ADDENDUM NO. 2

PROJECT: **Frog Eye Road Bridge Replacement**
County Contract No. BR-FE-225-14

FROG EYE ROAD
BRIDGE REPLACEMENT

COUNTY CONTRACT NO. BR-FE-225-14

SHEET NO.
2R

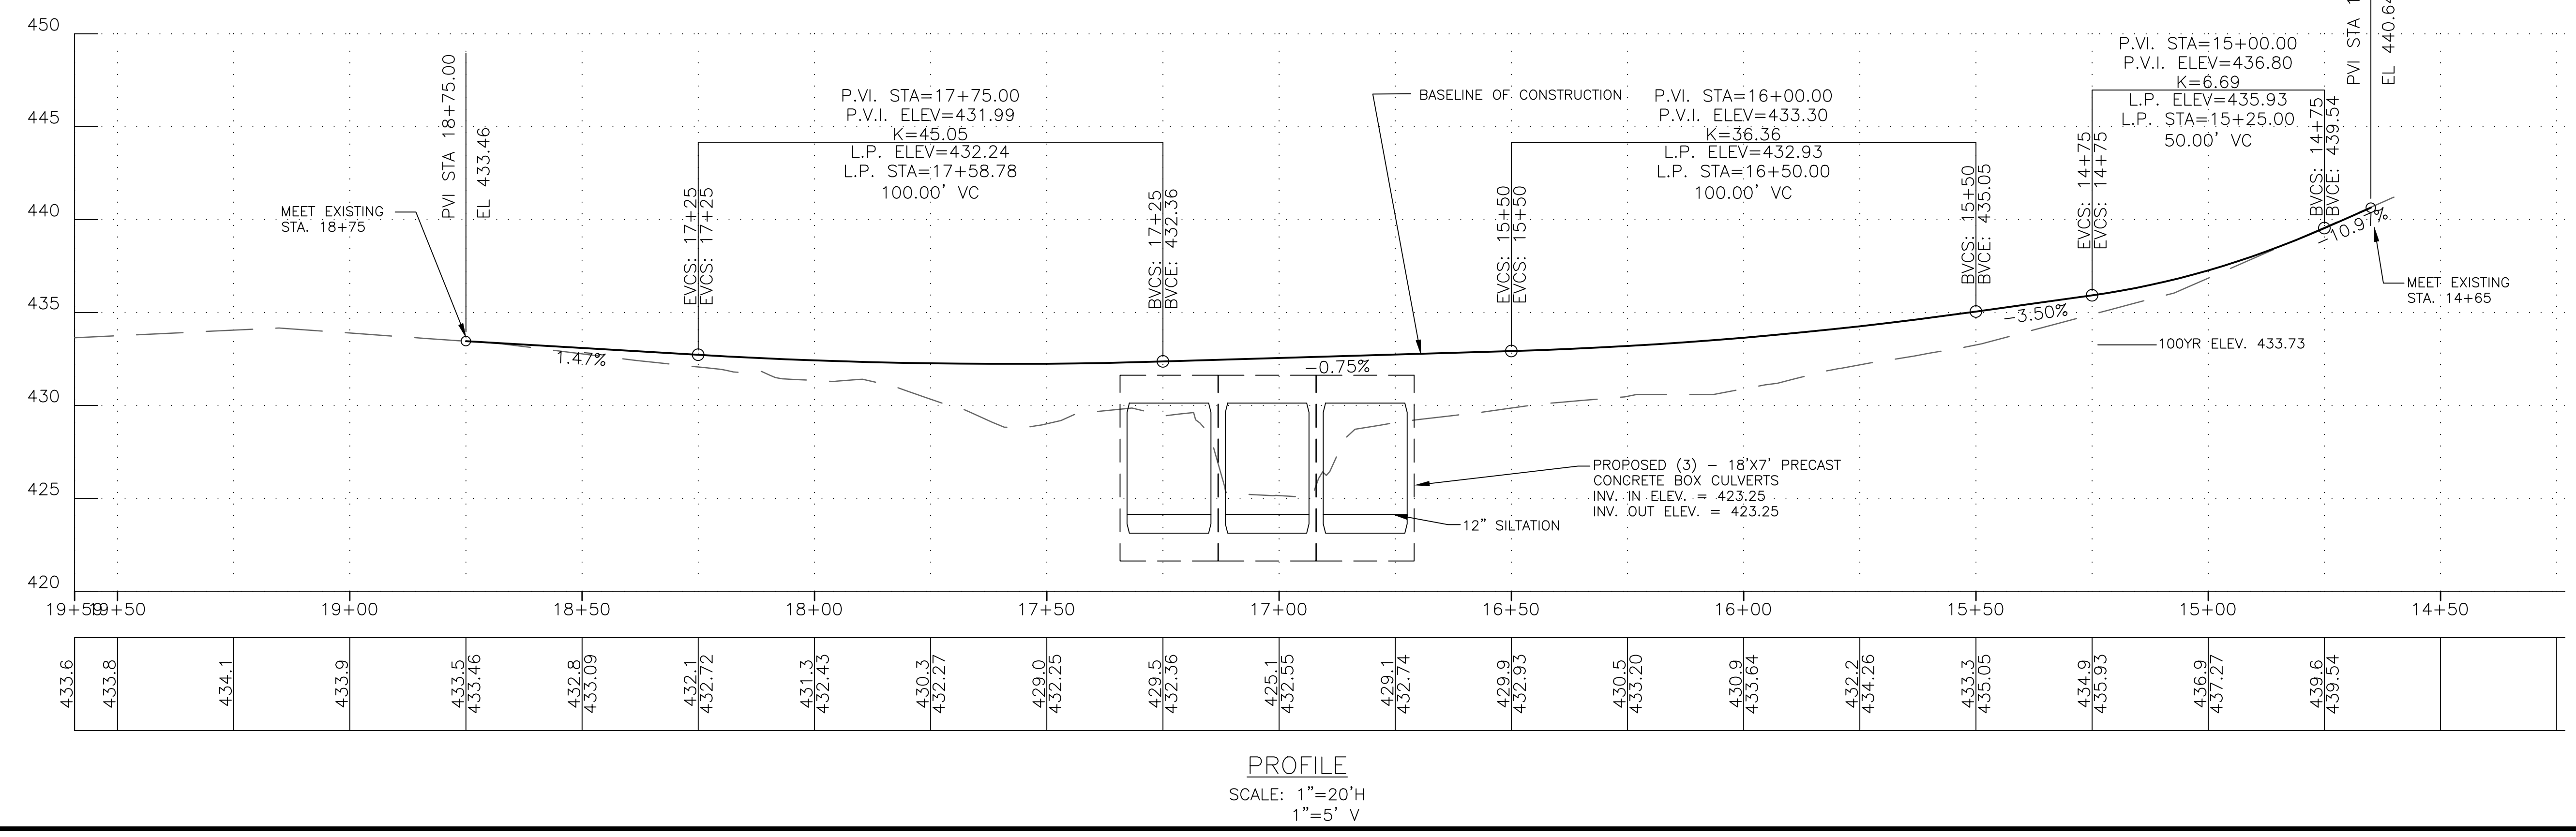
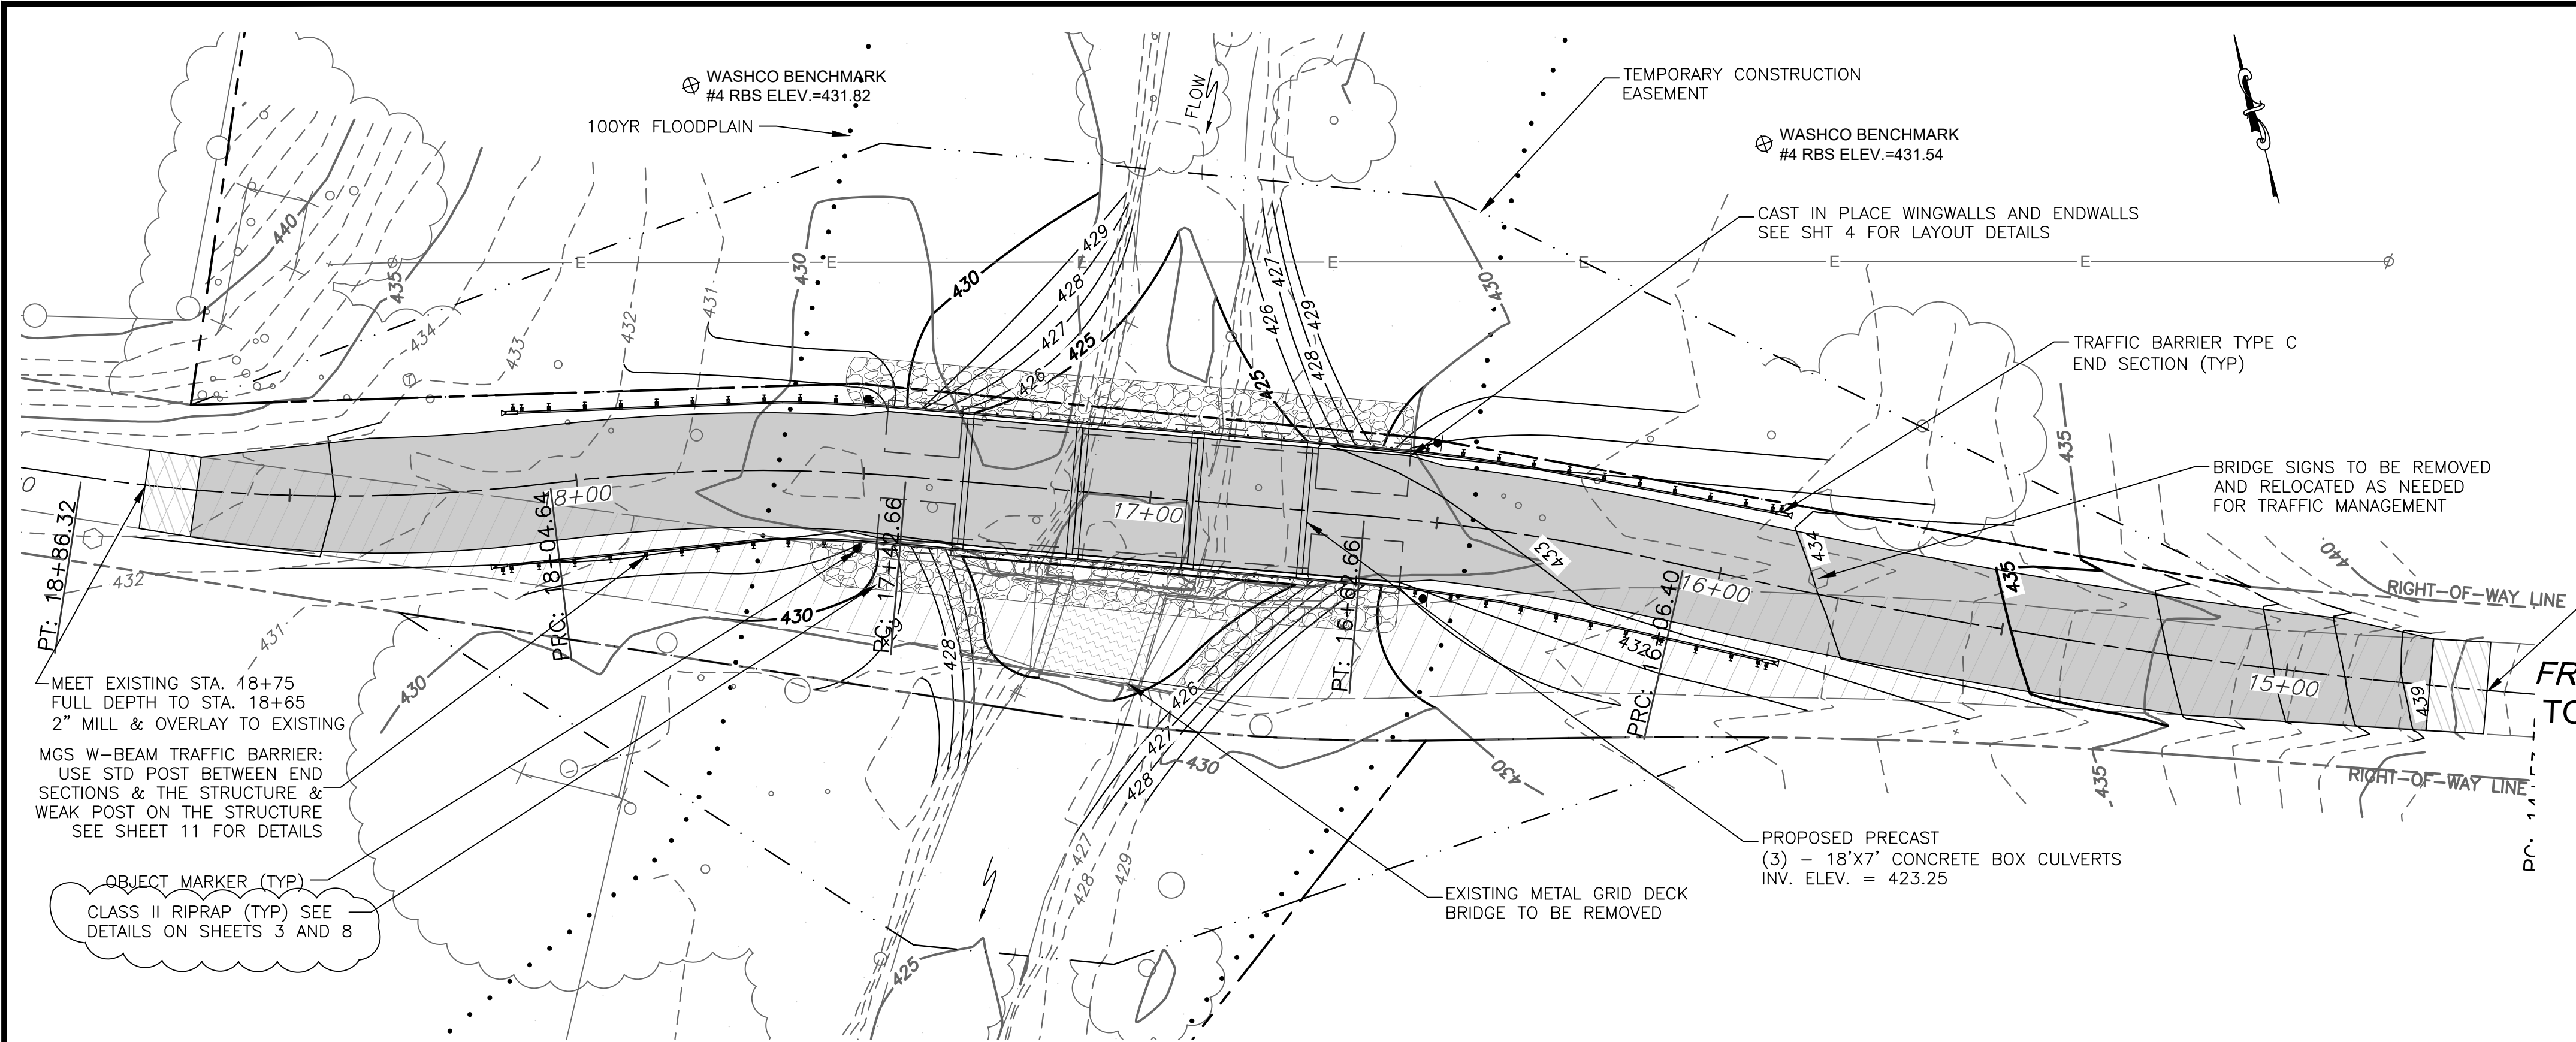
Q1: Is it possible to get a non-scanned PDF version of the plans for the subject project with better resolution? The legends and patterned areas are not clear on some sheets (e.g., sheet 2) such as the proposed pavement, pavement to be removed, and extents of the Class II Riprap.

Q8: Can the 39 SF quantity for item 801 (Permanent Traffic Signs) be clarified? Are there any proposed signs other than the object markers (OM-3L & OM-3R)? Where are the bridge signs indicated near STA 15+75 on sheet 2 as “to be removed and relocated as shown” proposed to be relocated? Are these to be new signs included in item 801 or just relocate the existing signs?

R1: Yes. See Item 2.02 above.

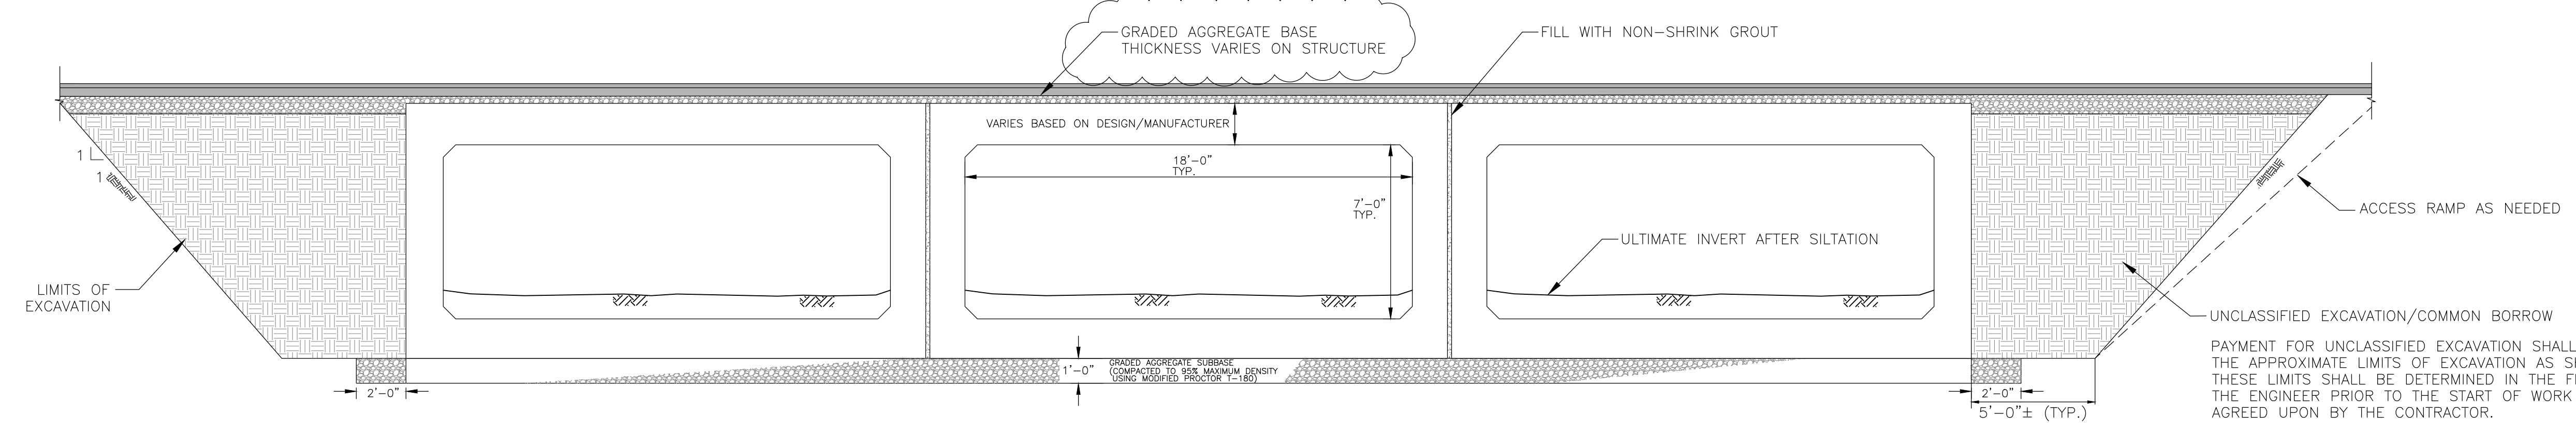
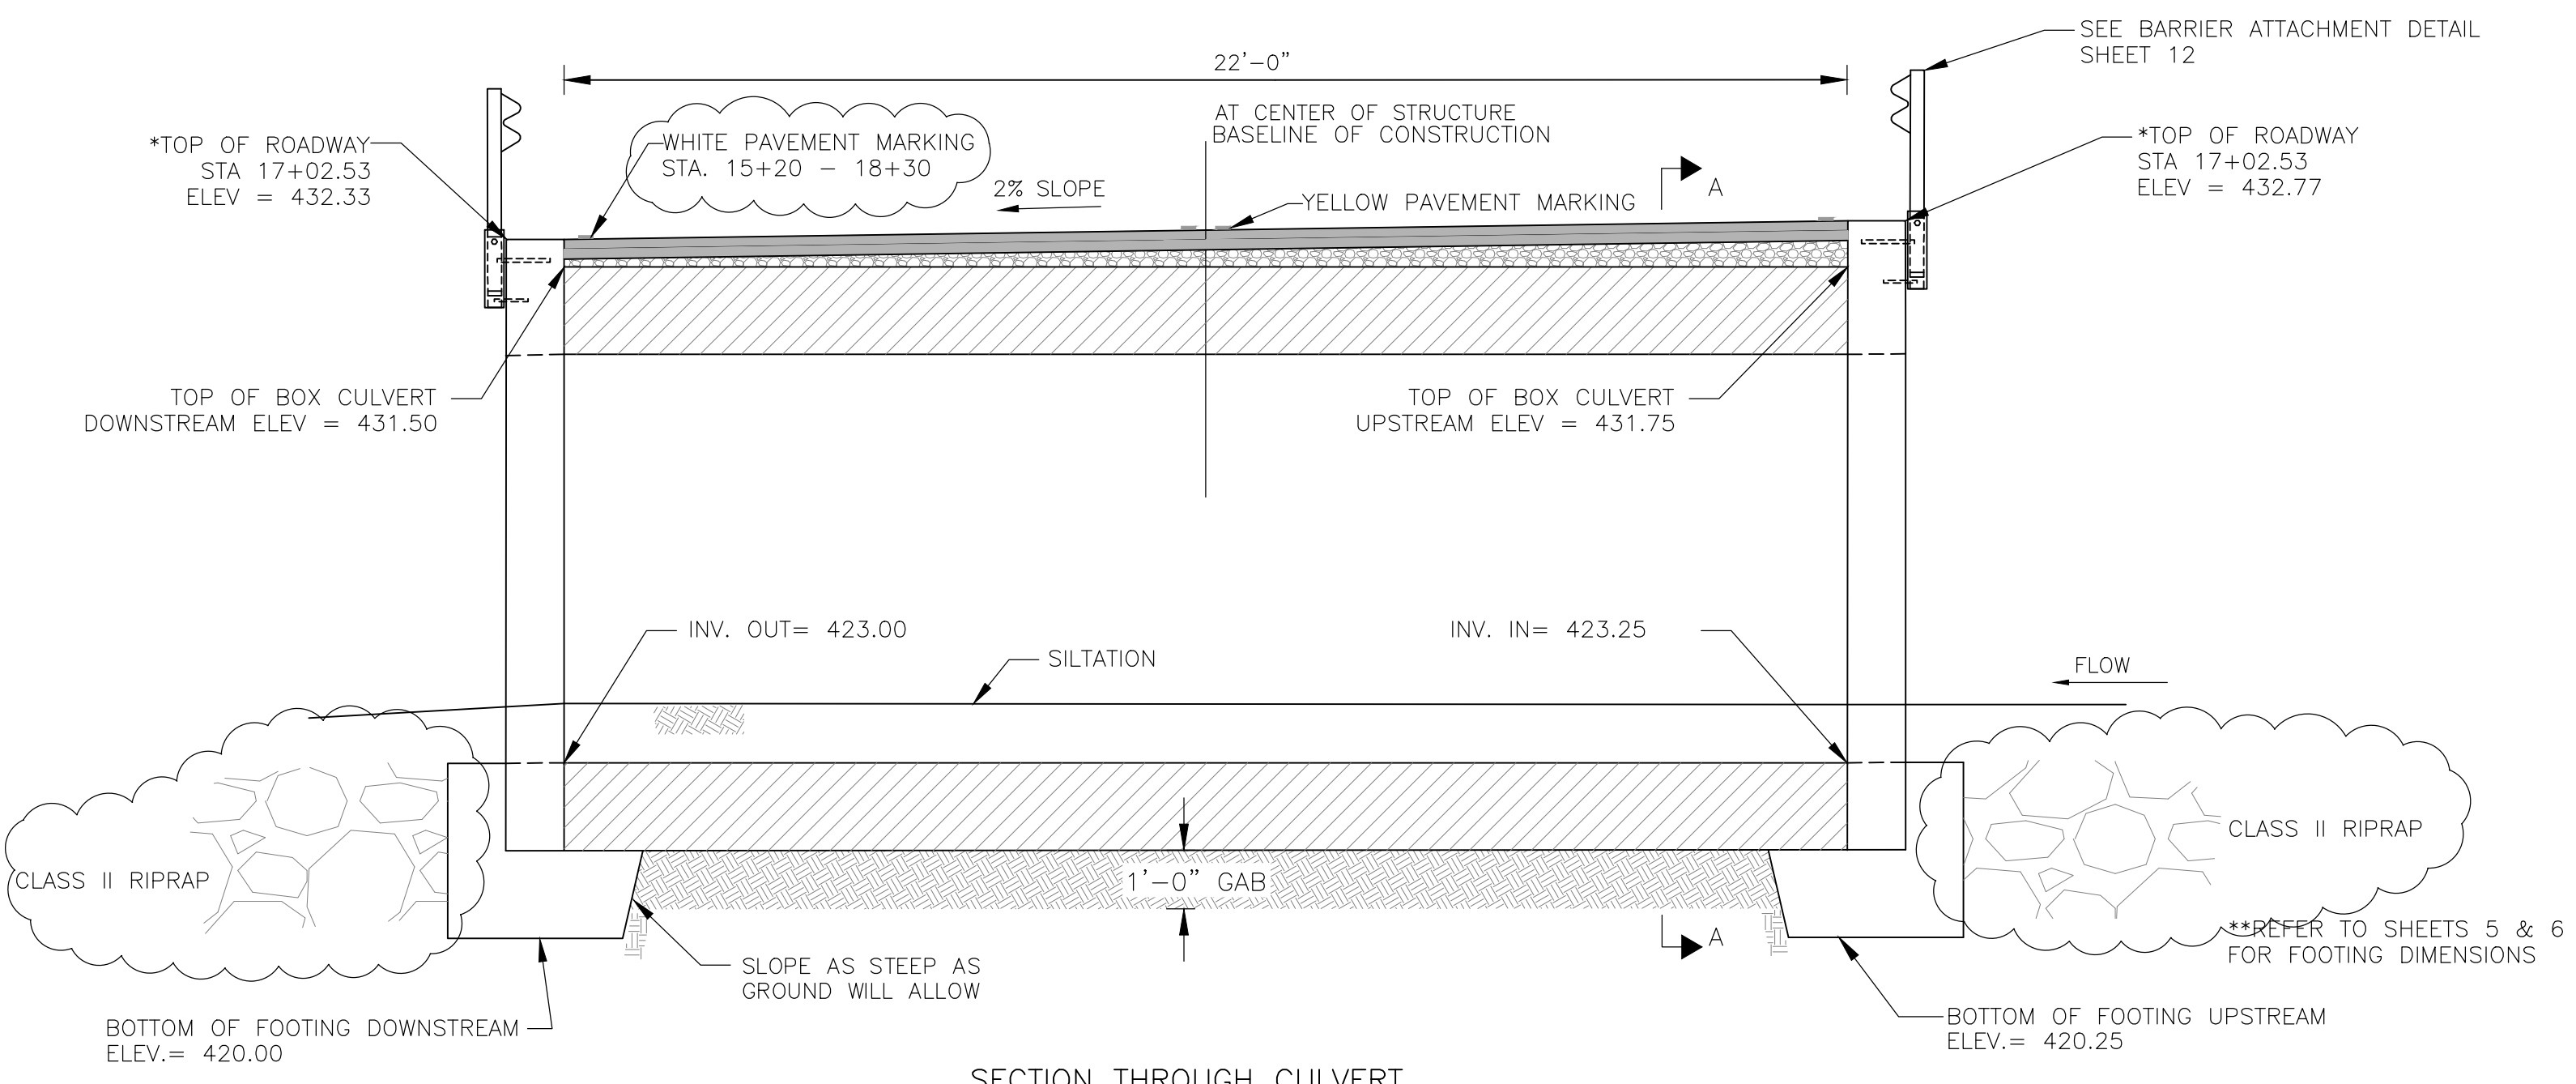
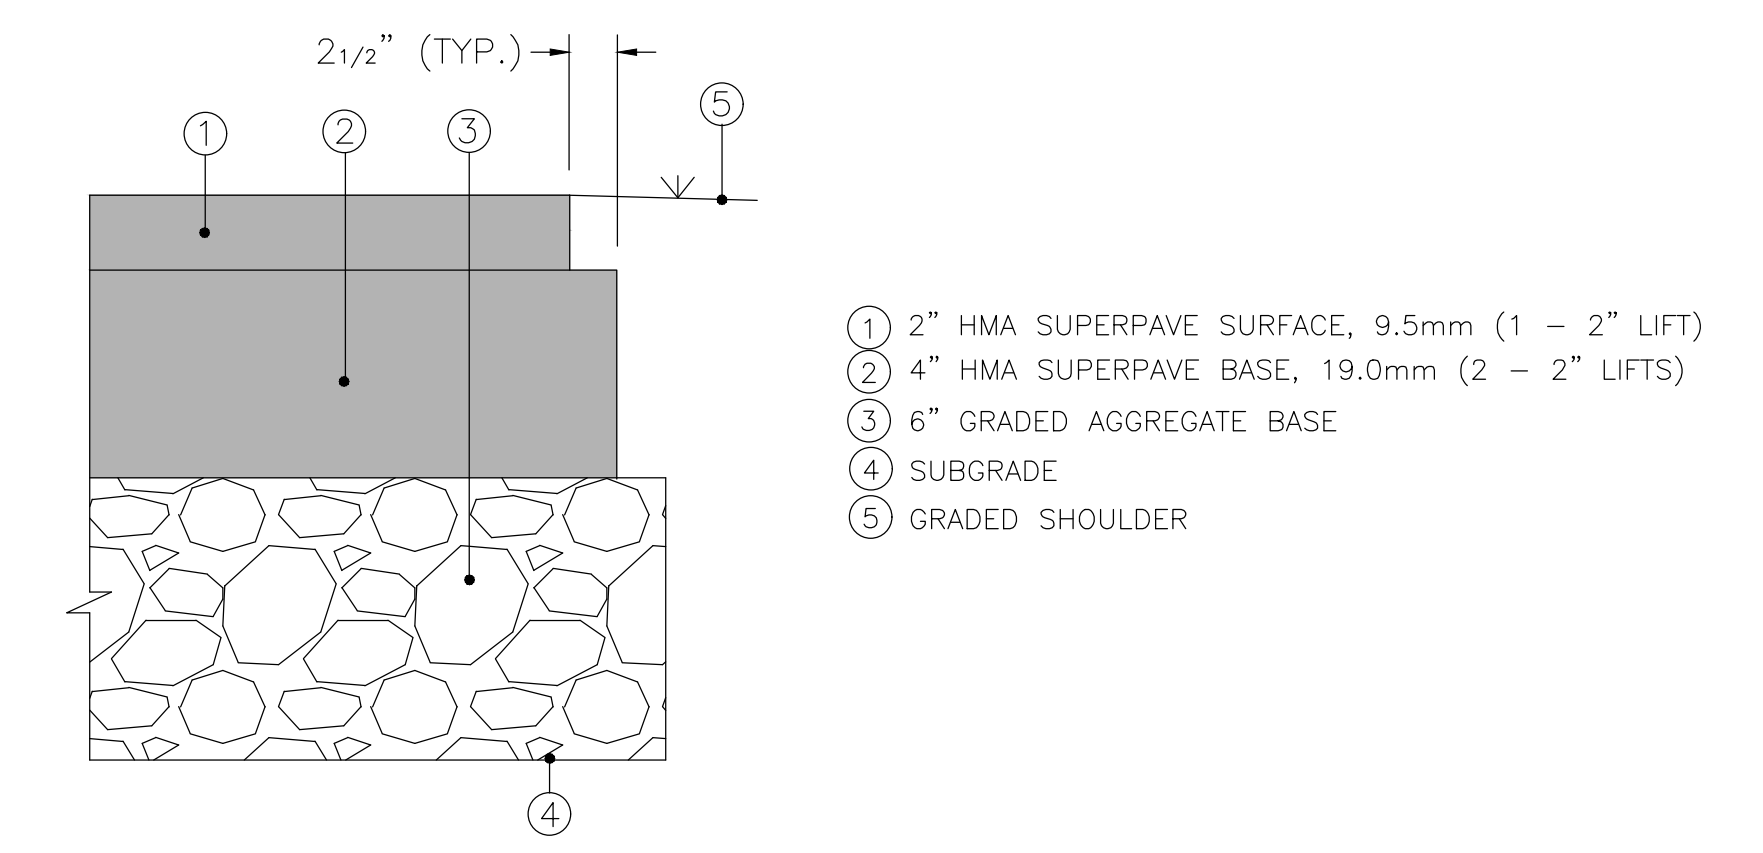
Q4: Please confirm it is 2-inch asphalt milling. How many Square Yards and how many locations? Please provide a plan sheet with clearly marked areas to be milled.

Q7: Can the quantities for the proposed pavement marking items (or the limits if not to be applied to entire project limits) be clarified? They appear to be low.

Q12: Is the proposed wearing surface on the culverts to be the same 2" HMA Superpave surface as the full depth paving? Is the varying depth included in the surface item?

R4: Yes, the 2-inch mill depth is correct as shown on the "Pavement Tie-In" detail included on plan sheet 3. Milling shall be performed at each end of the project where the roadway transitions back to and matches up with the existing pavement. The milling locations include from sta. 14+65 to 14+75; and from sta. 18+65 to 18+75, across the full pavement width as shown. Refer also to Q1/R1 above.

R7: Pavement Marking Paint shall be applied from Sta. 15+20 to Sta. 18+30. Refer to revised plan sheet 3R attached.

R12: The variable depth pavement section across the culverts will be taken up by adjustments to the compacted depth of the Graded Aggregate Base (GAB) to be placed across the structure. The depth of the surface and base HMA placement across the structure will stay consistent with the paving detail shown on plan sheet no. 3 and will not vary in depth.
